## ArevaEPRDCPEm Resource

Request for Additional Information No. 321, Supplement 3

U. S. EPR Standard Design Certification AREVA NP Inc. Docket No. 52-020 SRP Section: 07.01 - Instrumentation and Controls - Introduction Application Section: 7.1

### Question 07.01-19:

## 7.1.1.2.3 Application of the TXS Platformand QDS Platforms

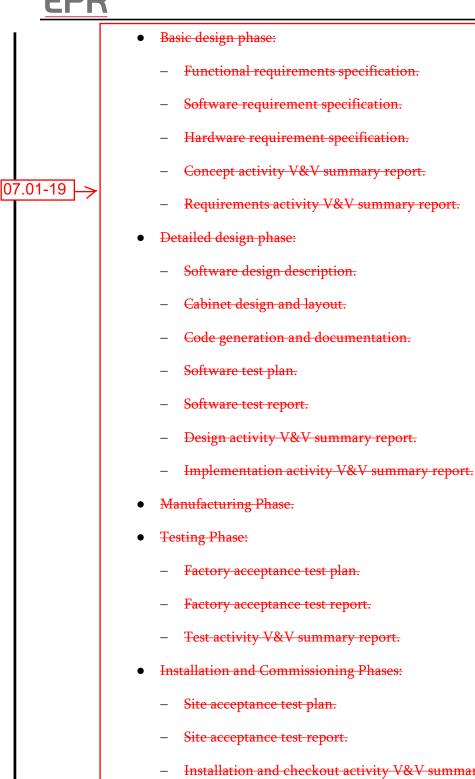
Describe the software development process (SDP) used for the video display that will be used in the safety information and control systems (SICS), particularly with respect to identification of aspects that differ from the SDP used for the TELEPERM XS.

The applicant needs to provide a description of the differences in the SDP for the safety-related video display. The staff needs to be able to determine acceptability with regards to the quality requirements of 10 CFR 50.55a(a)(1); 10 CFR Part 50, Appendix A, General Design Criteria 1; 10 CFR Part 50, Appendix B; and 10 CFR 50.55a(h) are met.

TELEPERM XS Software Topical Report (ANP-10272) (Reference 8) describes the lifecycle processes for application software development used in safety-related applications of the TXS and <u>ODS</u> platforms for the U.S. EPR, as well as software V&V processes. These phases are listed below along with the primary <u>activities included in</u> documentation generated at the end of each phase:

- Basic design:
  - <u>System requirements.</u>
  - <u>System design.</u>
  - <u>Software requirements.</u>
  - <u>Initiate software requirements traceability.</u>
  - Summary reports for V&V activities (i.e., acquisition support, planning, concept, and requirements).
- <u>Detailed design:</u>
  - <u>Software design.</u>
  - <u>Automatic code generation.</u>
  - <u>Application software integration validation test planning (using an NRC-approved simulation test tool).</u>
  - Application software integration validation test execution (using an NRCapproved simulation test tool).
  - <u>Application software integration validation test reporting (using an NRC-approved simulation test tool).</u>
  - <u>Software safety analyses.</u>
  - <u>Continue software requirements traceability.</u>
  - Hardware design.
